Amendments to the Drawings:

Attachment: Replacement Sheet
Annotated Sheet Showing Changes

REMARKS

Fig. 7

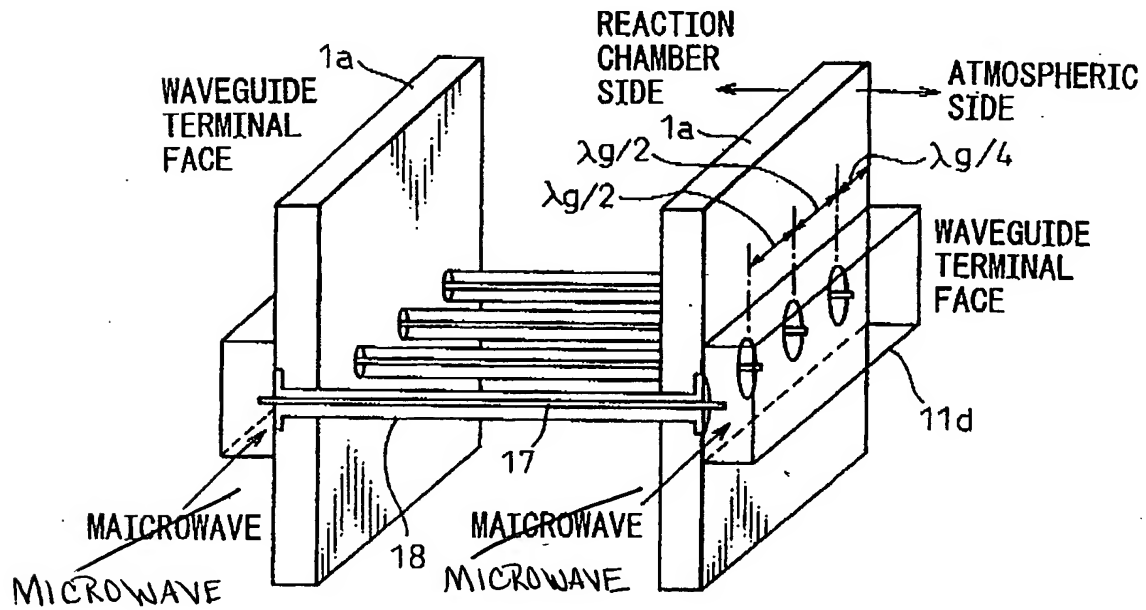
The attached sheets of drawings includes changes to Figs. 7, 19, 20, 21, 22, and 23. As suggested by the Examiner, in Figures 7, 19, 20, 22 and 23, "MAICROWAVE" has been changed to "MICROWAVE". Figure 21 has also been amended to change "MIROWAVE" to "MICROWAVE".

Replacement drawings are provided herewith as explained on the earlier page entitled “Amendments to the Drawings.” In response to the objections to the drawings, Applicants have amended Figures 7, 19, 20, 22, and 23 by changing “MAICROWAVE” to “MICROWAVE” and Figure 21 has been amended to change “MIROWAVE” to “MICROWAVE” as suggested by the Examiner, thereby rendering these objections moot. Reconsideration and withdrawal of these objections are therefore respectfully requested.
